Informational Maps and Summary of Record Plats for the Planning Board

Agenda for January 31, 2008

#### PLAT NO. 220080510

### Decoverly Hall

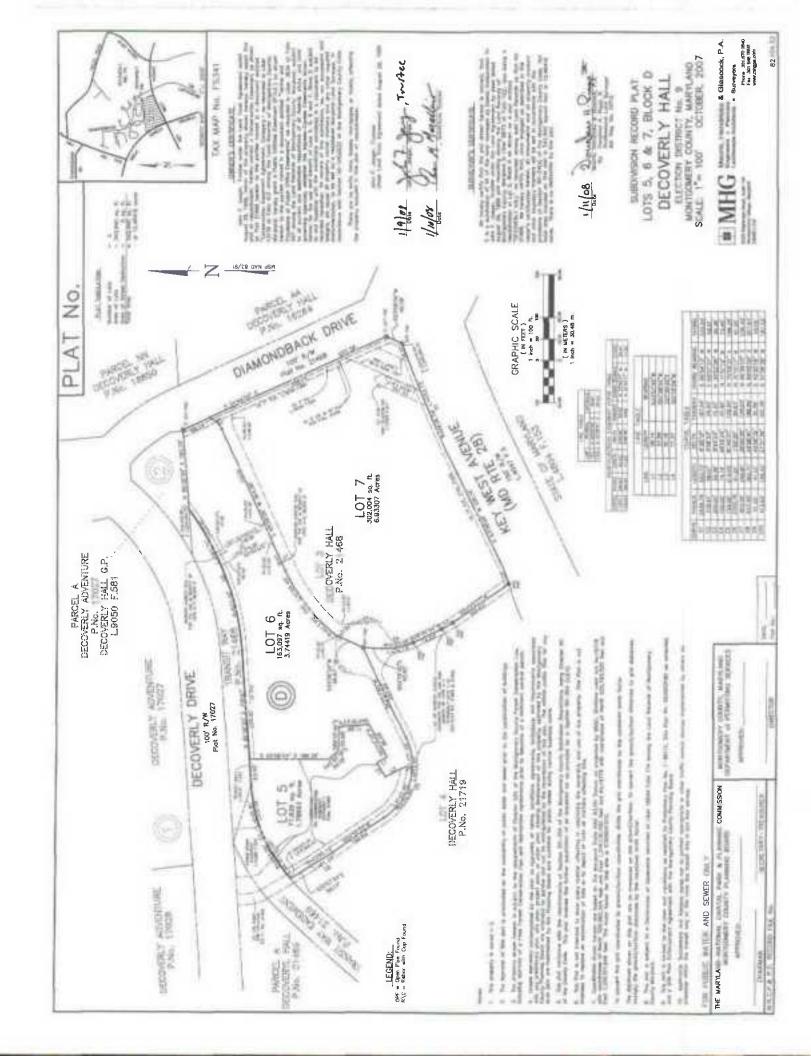
Staff recommends approval of this subdivision plat pursuant to section 50-35A(a)(4) of the Subdivision Regulations, which states:

Staff applied the above-noted criteria for this property and concludes that the proposed subdivision complies with the criteria of Section 50-35A(a)(4) of the subdivision regulations and supports this minor subdivision record plat.
